**TOWN OF NEWBURGH
PLANNING BOARD
TECHNICAL REVIEW COMMENTS**

PROJECT NAME: MKJC REALTY, LLC
PROJECT NO.: 2023-11
PROJECT LOCATION: SECTION 35, BLOCK 3, LOT 3.22/ NYS ROUTE 32
REVIEW DATE: 30 AUGUST 2023
MEETING DATE: 7 SEPTEMBER 2023
PROJECT REPRESENTATIVE: LANC & TULLY

Re: Site Plan for MKJC Realty LLC
SBL: 35-3-3.22
NYS Route 32
Planning Board #2023-11

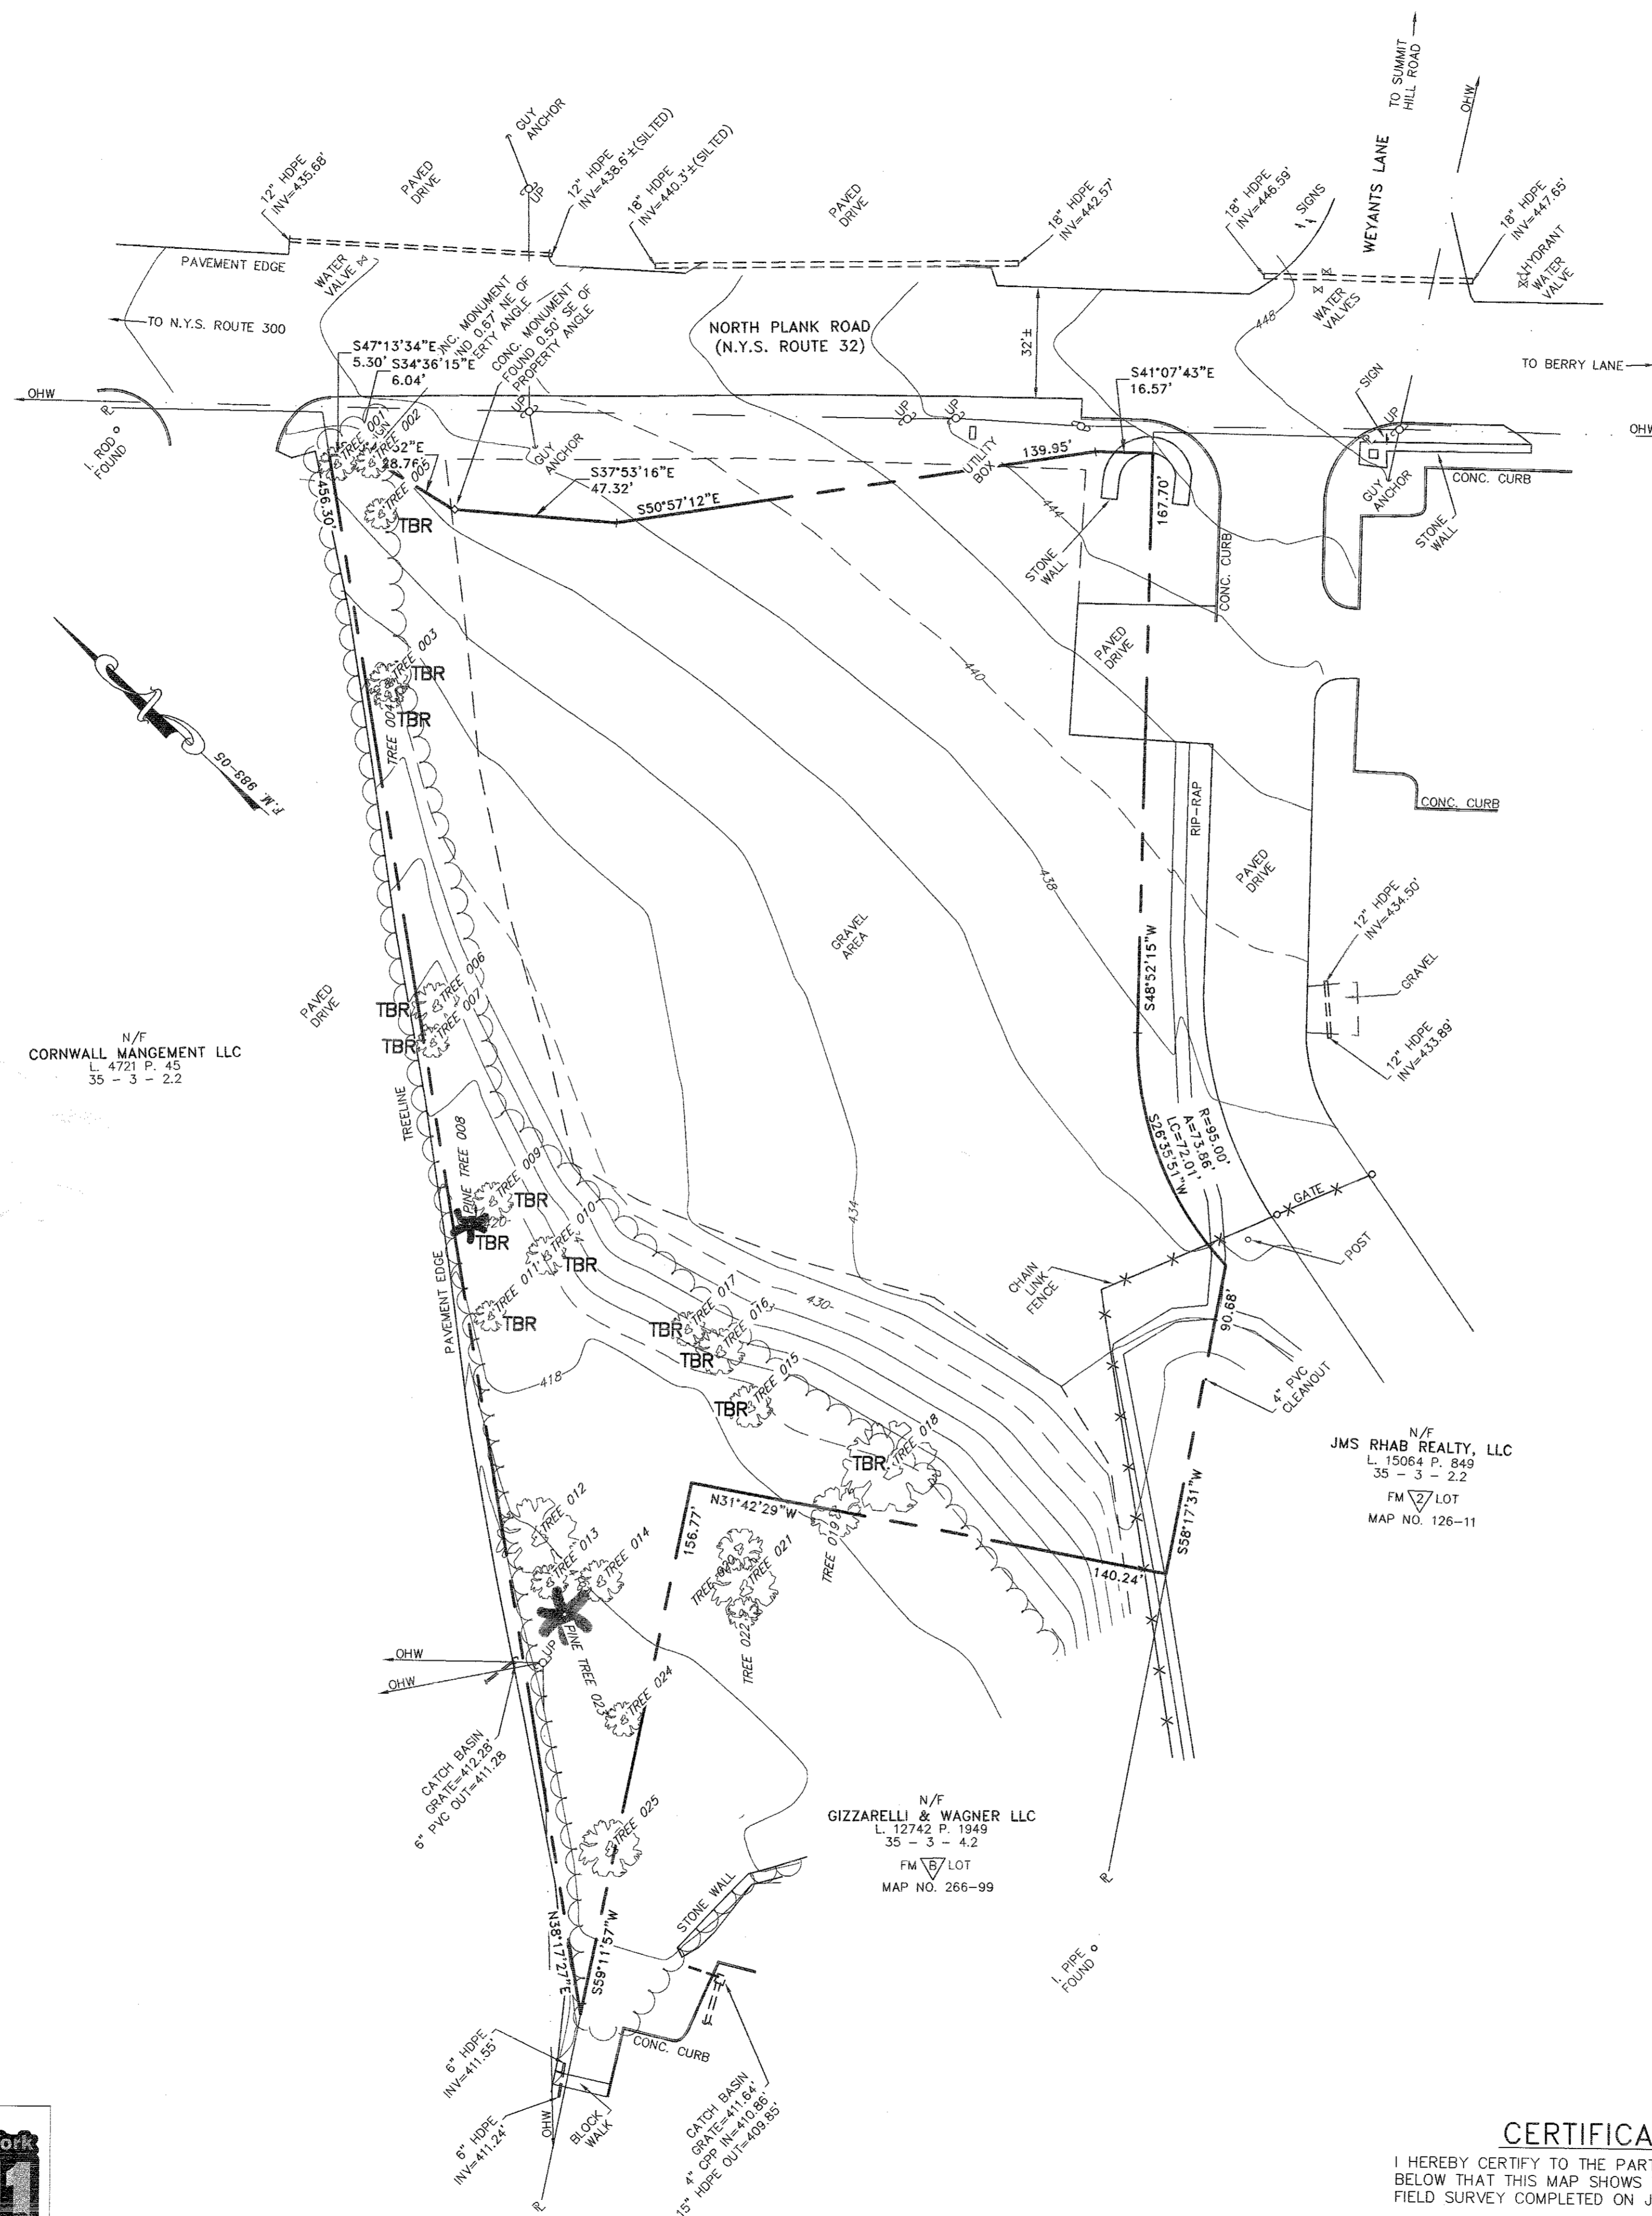
8. The Tree Preservation Plan should identify the percent of trees to be removed. Species of trees should be identified in the Tree Preservation Plan. It appears that only one tree greater than 20 inches is proposed to be removed.

16. Actual Field Survey will be required as part of the Site Plan.
Response: A field survey has been completed.
17. Tree Preservation Ordinance compliance should be documented.

Response: The property existing trees and sizes have been provided on the plans and the trees to be removed have been denoted.

Response: The onsite trees have been located and tagged on the property. The diameter and status of the tree has been provided. Within future submissions, the tree species shall be provided.

Response: The trees have been located and tagged with nails, on the property. The tree plan has been provided within the plan set.

SEWAGE DISPOSAL SYSTEM DESIGN
 PREPARED FOR

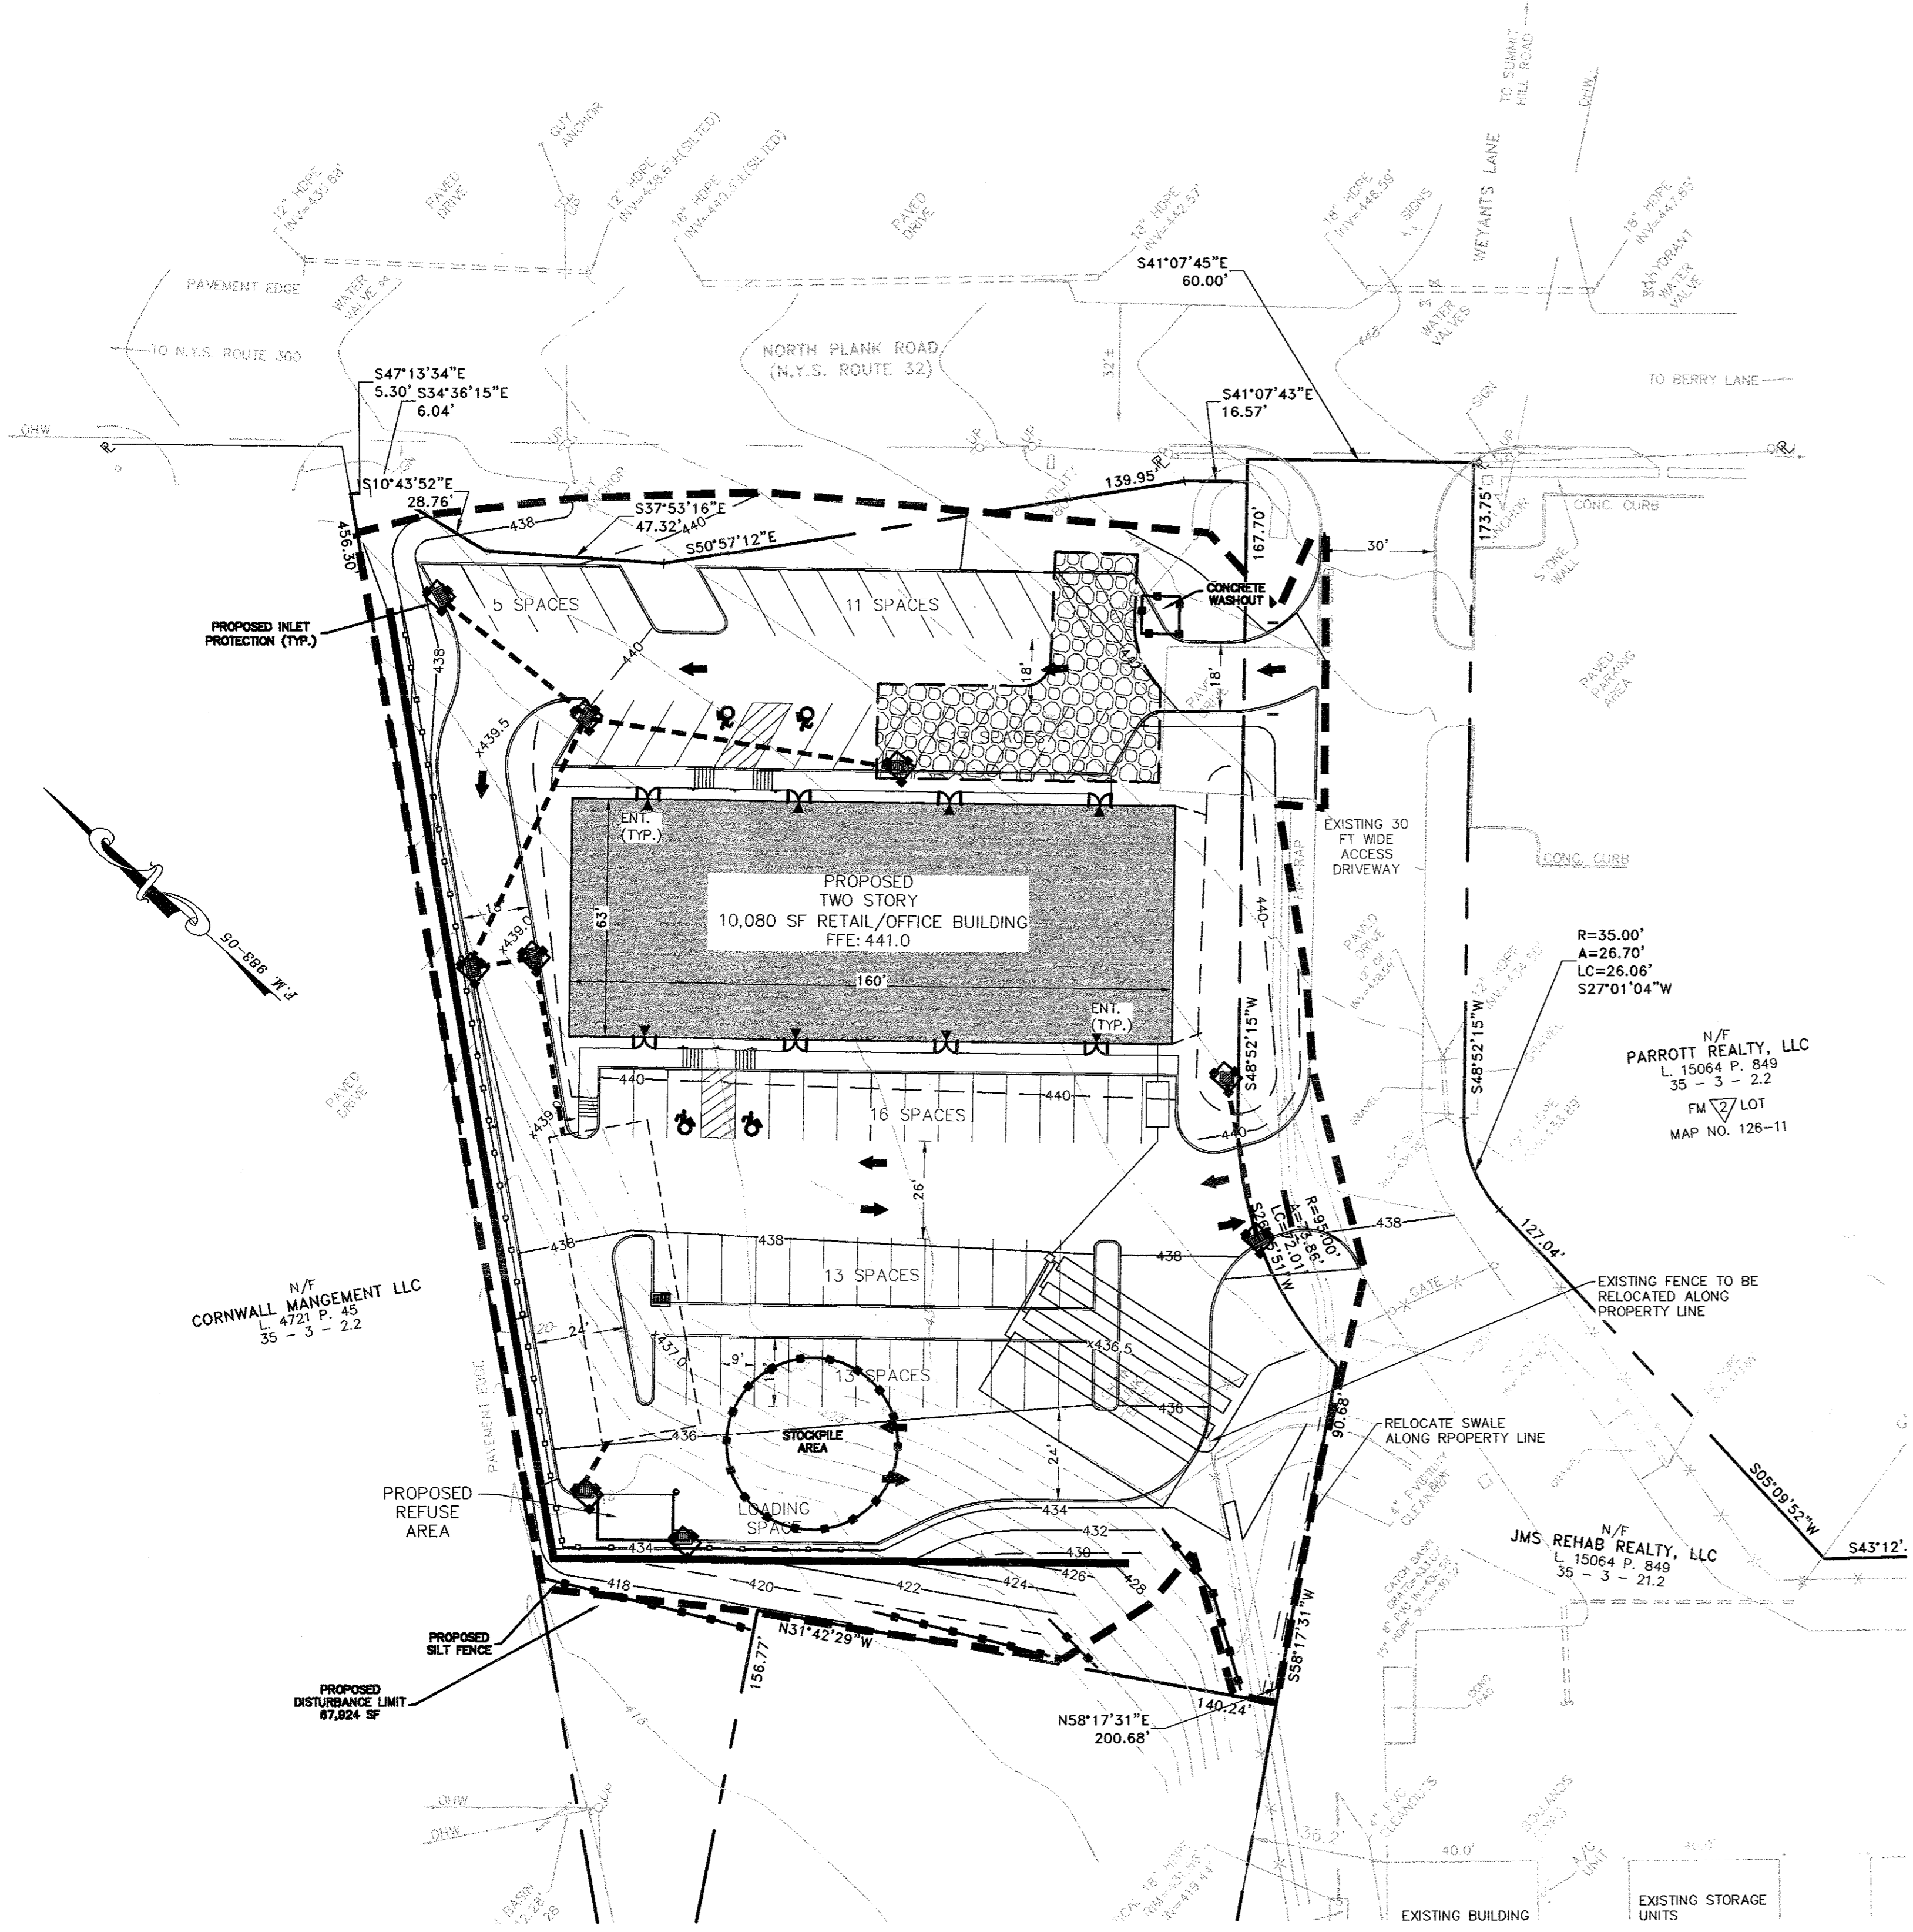
5. The subsurface sanitary sewer disposal system is depicted to be constructed under pavement. Orange County Department of Health approval for the alternative system will be required.

TYPICAL SECTION-REINFORCED RETAINING WALL
NOT TO SCALE

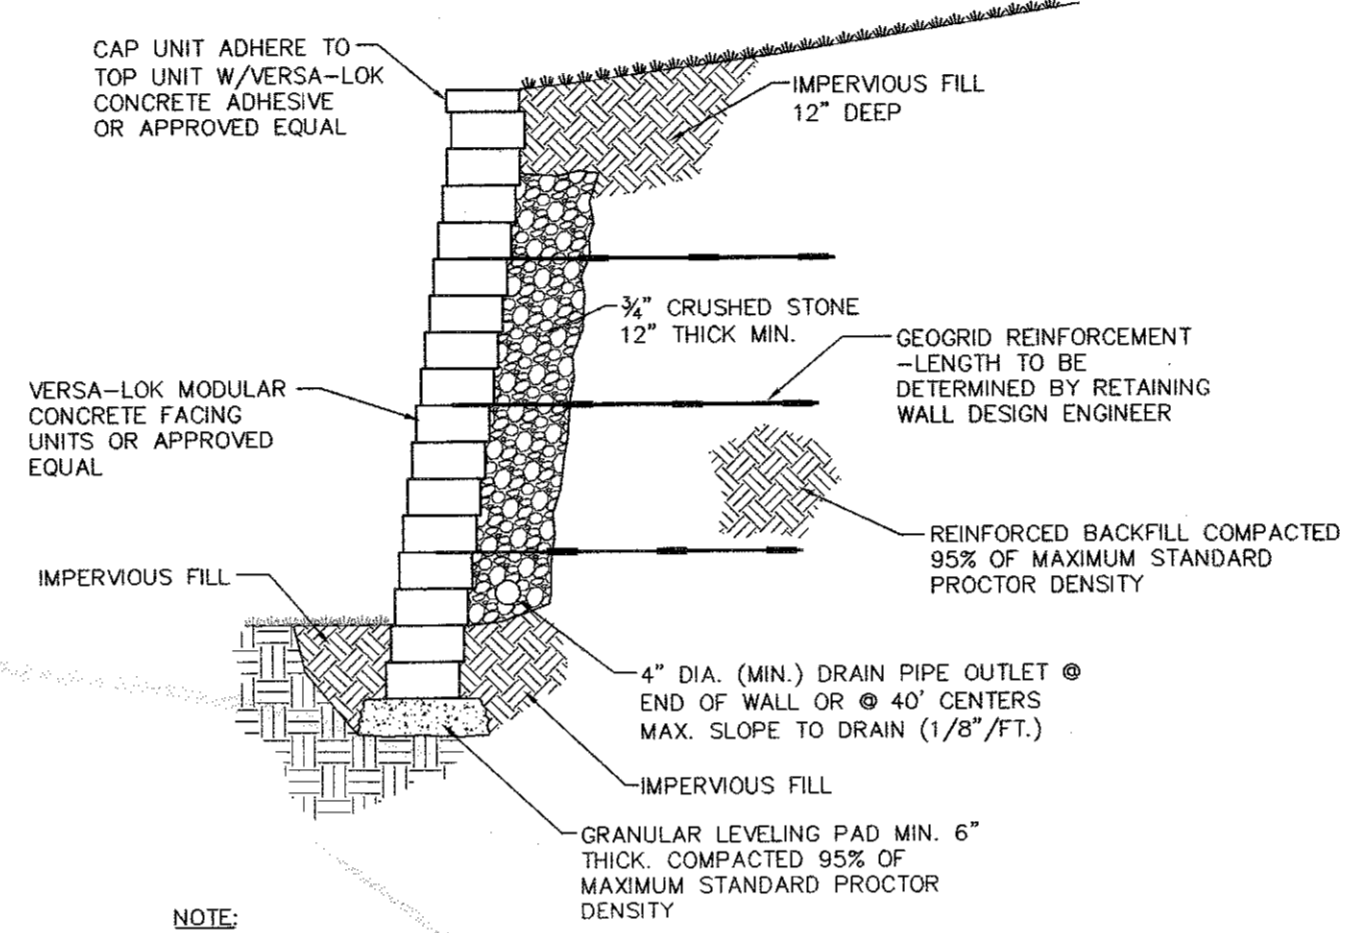
9. A substantial retaining wall is proposed along the north and westerly side of the development. Wall is approximately 18 feet high at its highest point along the northern property line.

11. ARB approval for the structure is required. Building plans should be submitted for review.
12. Design of the retaining wall should be addressed on the plans.
13. The water line connection for fire and potable water should be depicted on the Utility Plan.
14. NYSDOT approval for utilities and grading within their right-of-way is required.
15. Documentation of the easement for access from Tax Lot 21.2 should be submitted for Dominic Cordisco's review.
16. Parking lot striping should be consistent with Town of Newburgh requirements utilizing double striping. (Detail Attached)
17. Plans contain a bio-retention detail. Location of the bio-retention area is not depicted on the plans.
